GLOBAL SAFETY FIELD INVESTIGATIONS
DCS5413
URGENT - DISTRIBUTE IMMEDIATELY

Subject: N192289390 - Special Coverage
Seat Belt Anchor Pretensioner Cable

Models: 2014-2017 Chevrolet Silverado
2014-2017 GMC Sierra

N192289390 Seat Belt Anchor Pretensioner Cable

4522274

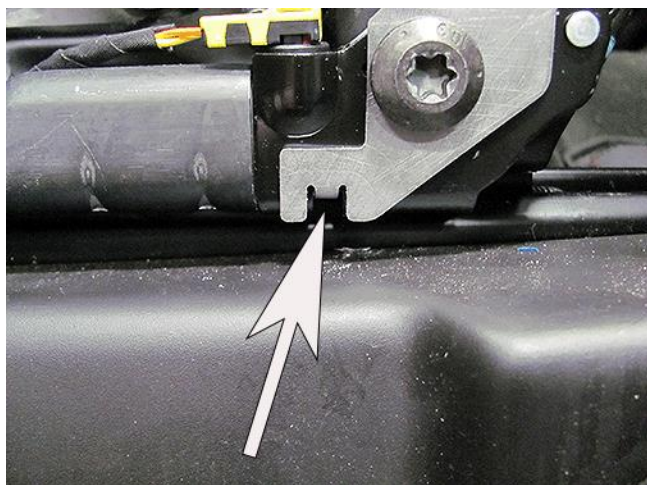
This damage will be in the form of holes (1) or splitting (2).

- If **any damage** is found, replace the driver side front seat belt anchor plate tensioner and the front seat cushion outer finish cover.
- If no damage is found, inform the customer that the special coverage condition is not present on their vehicle at this time.

| Correction | Dealers are to replace the pretensioner and side shield for all customers that experience a broken pretensioner cable or come to a dealership with excessive wear on the cable sleeve. The repairs will be made at no charge to the customer. |

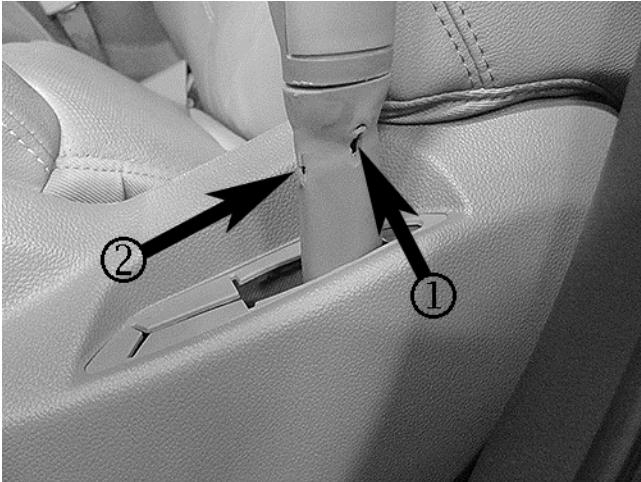
This damage will be in the form of holes (1) or splitting (2).

- If **any damage** is found, take the vehicle to the dealer for service.
- If no damage is found, the special coverage condition is not present on the vehicle at this time.
